HUNTS POINT INTERSTATE ACCESS IMPROVEMENT PROJECT – CONTRACT 3

PIN X731.65, Contract D900055

Addendum #8

July 22, 2022

INDICATIVE PLANS
WORK ZONE TRAFFIC CONTROL
AT-GRADE
STAGE 2-1
SHEET 1

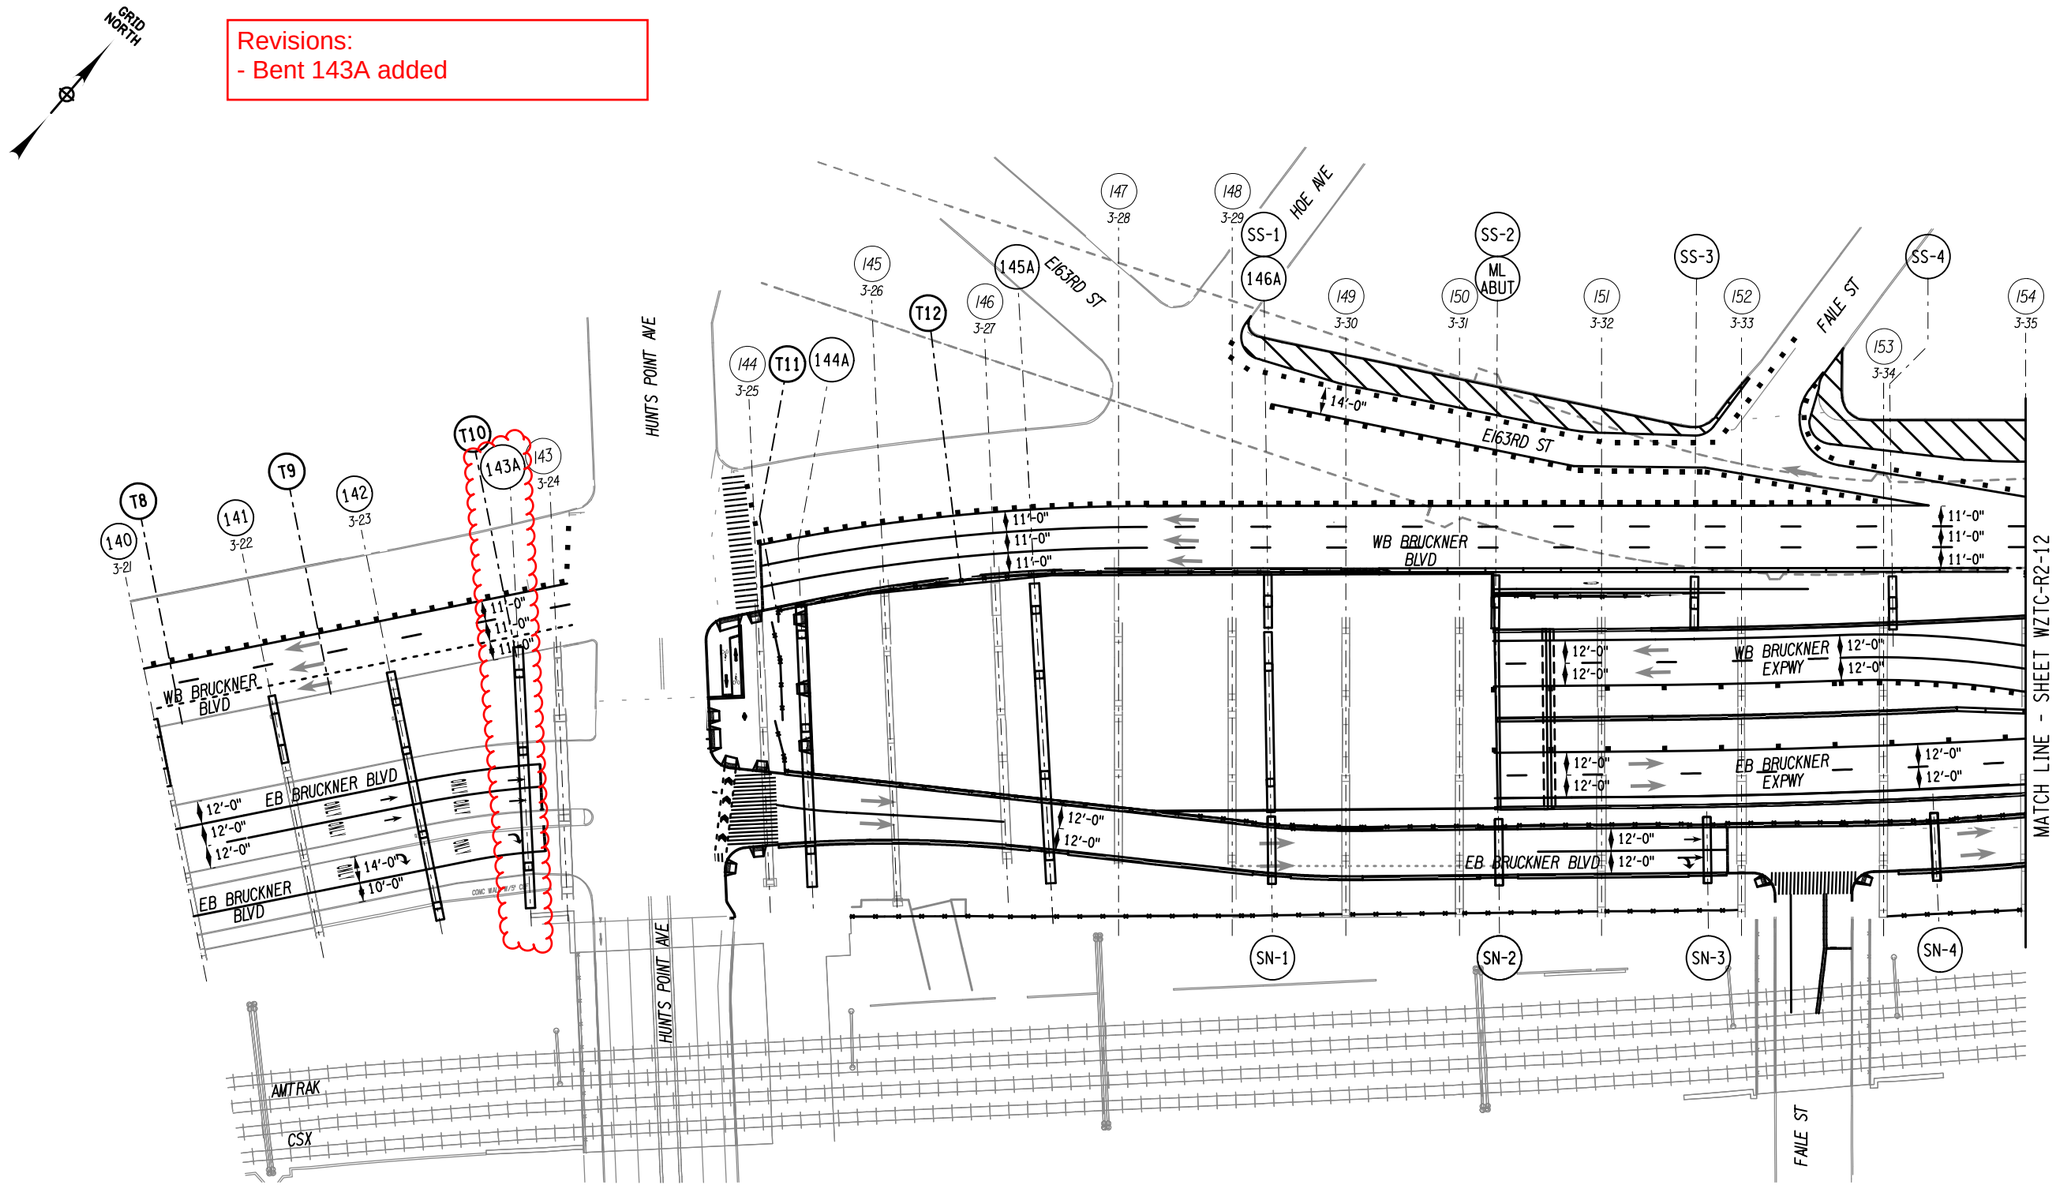
Revisions:
- Bent 143A added

INDICATIVE PLANS
WORK ZONE TRAFFIC CONTROL
AT-GRADE
STAGE 2-2
SHEET 2

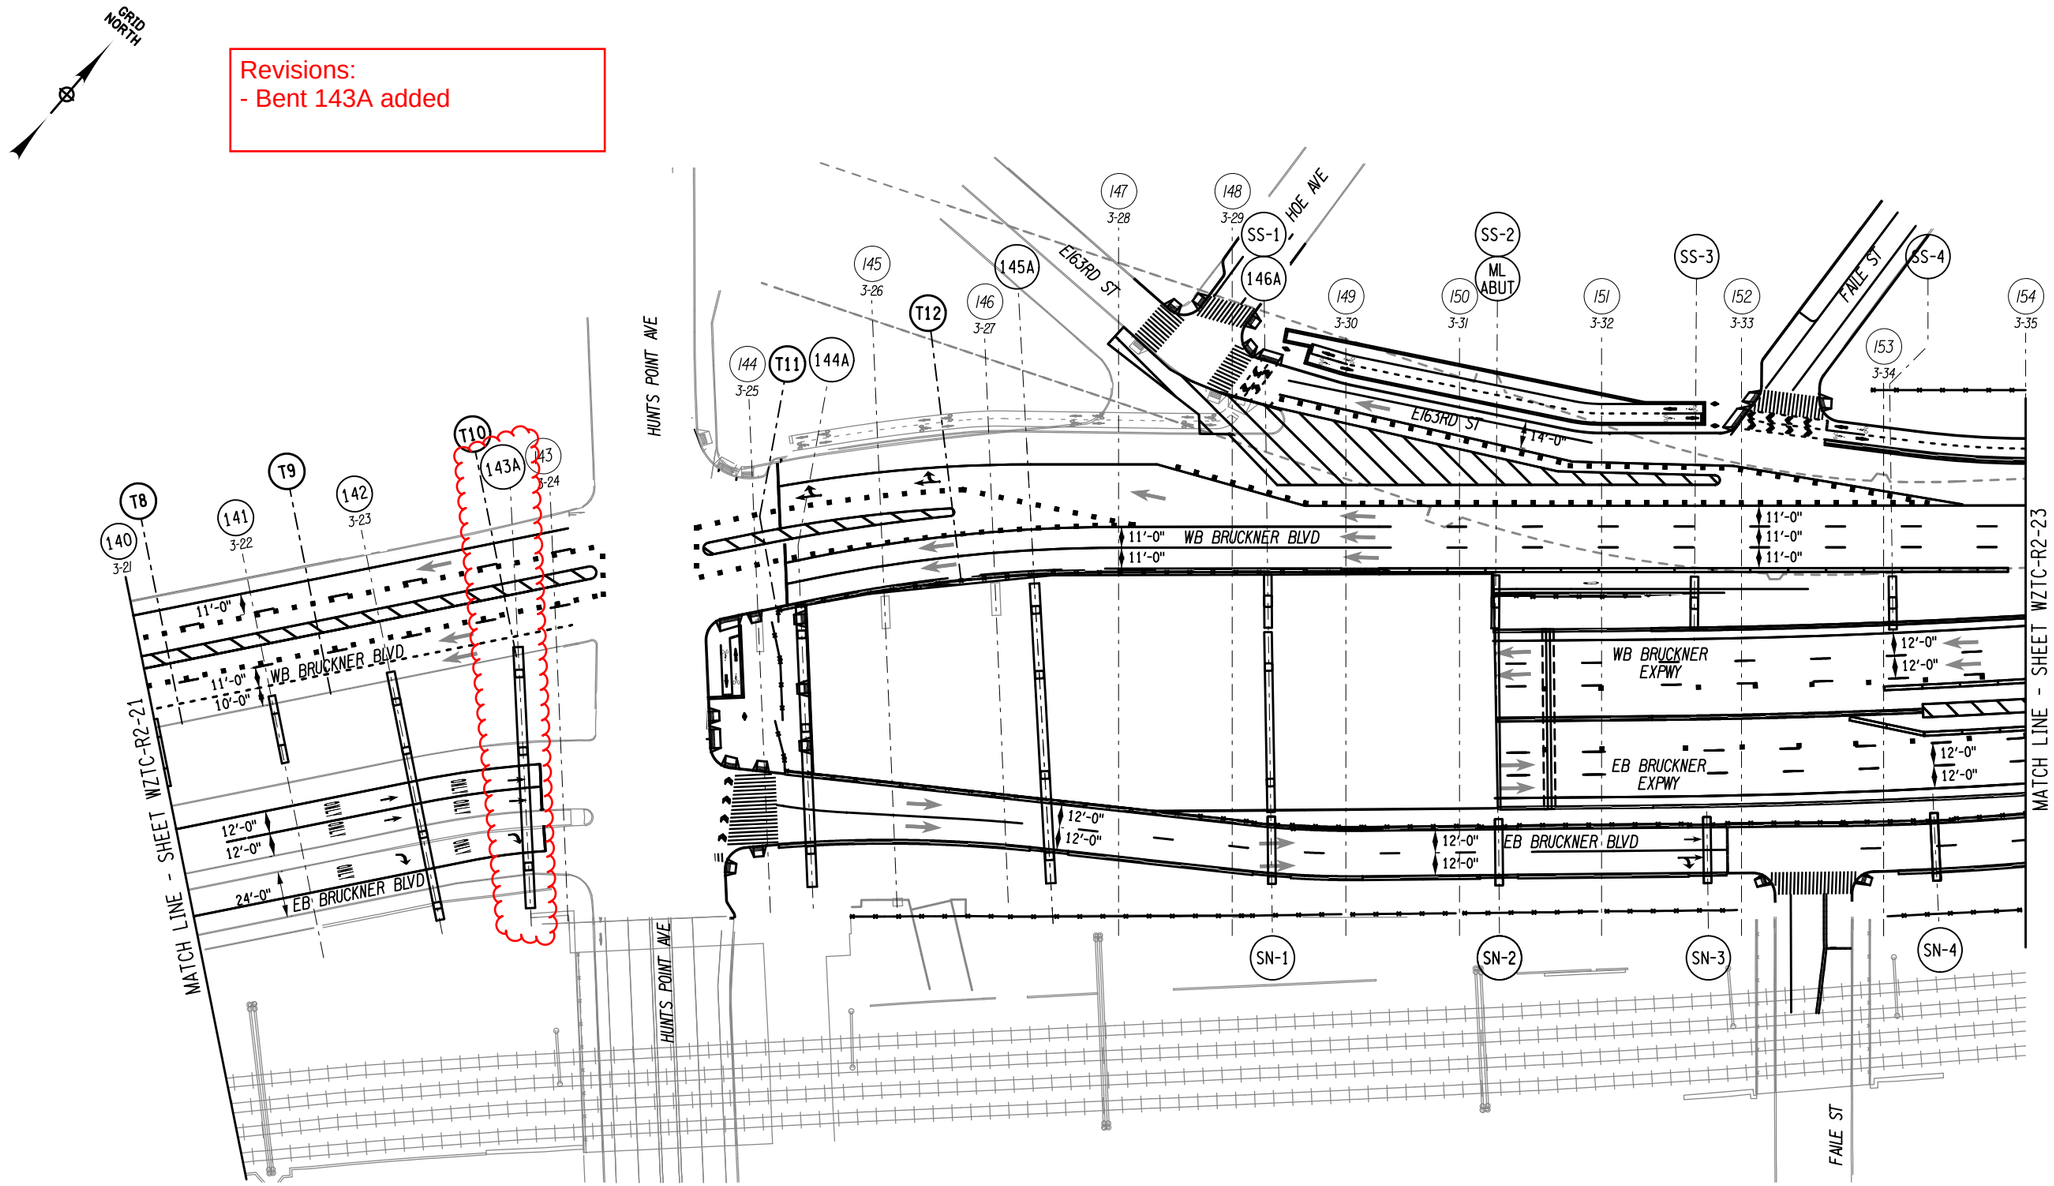
Revisions:
- Bent 143A added

STAGE 1-3
BENT 144 SHOWN
BENT 144A PROJECTED
(LOOKING NORTH)
N.T.S.

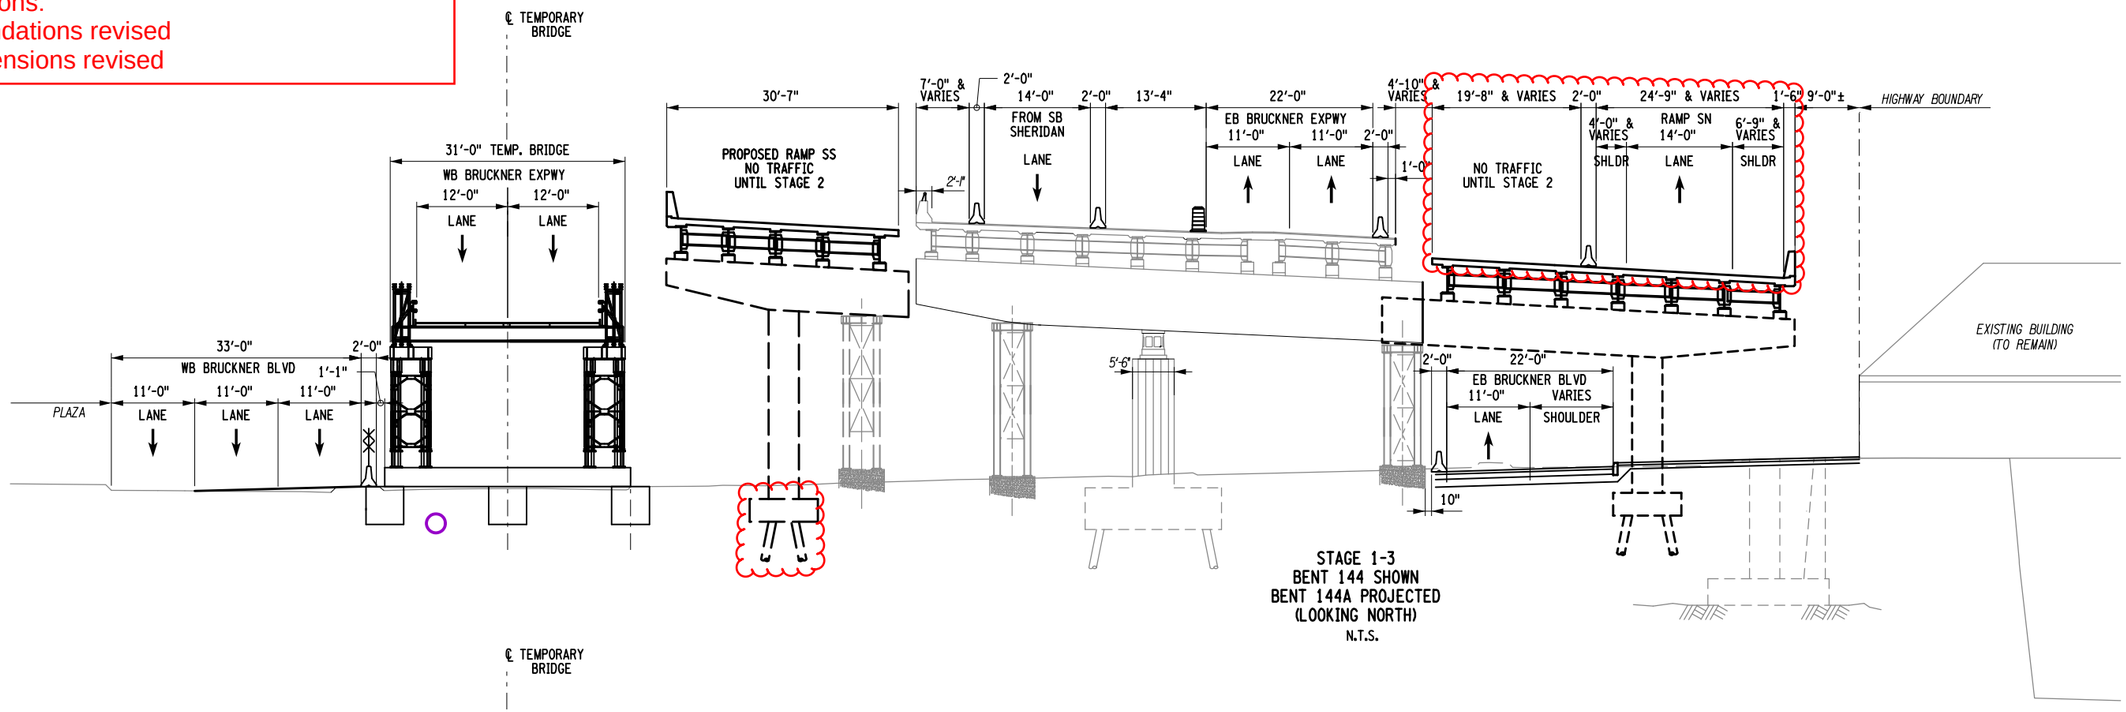
Revisions:
- Foundations revised
- Dimensions revised

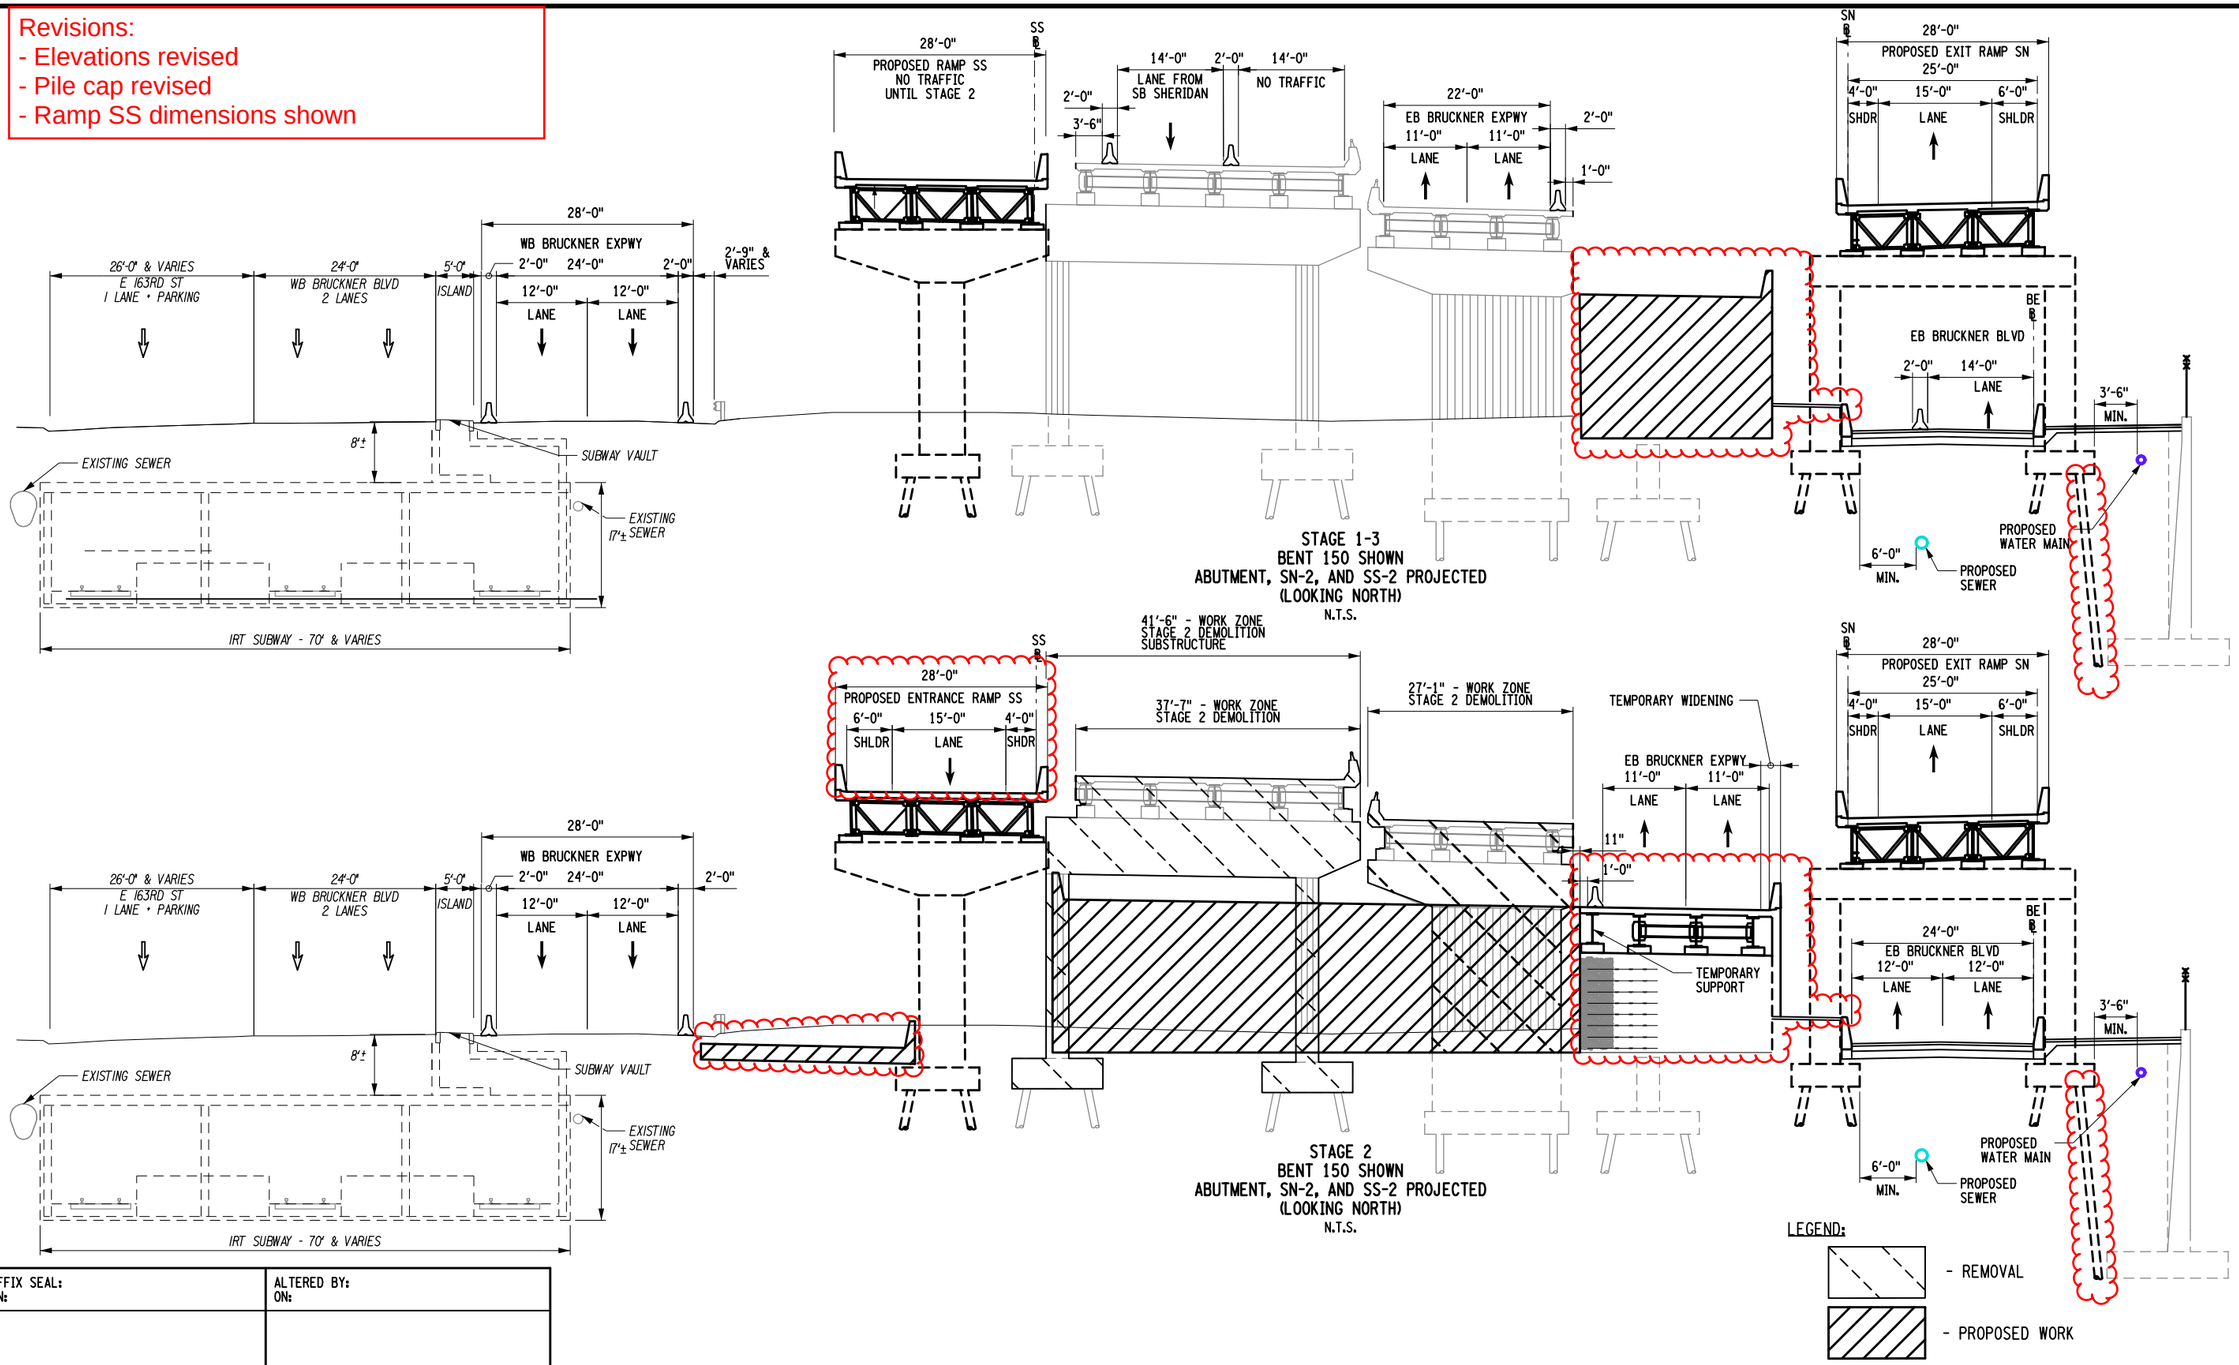
Revisions:
- Elevations revised
- Pile cap revised
- Ramp SS dimensions shown
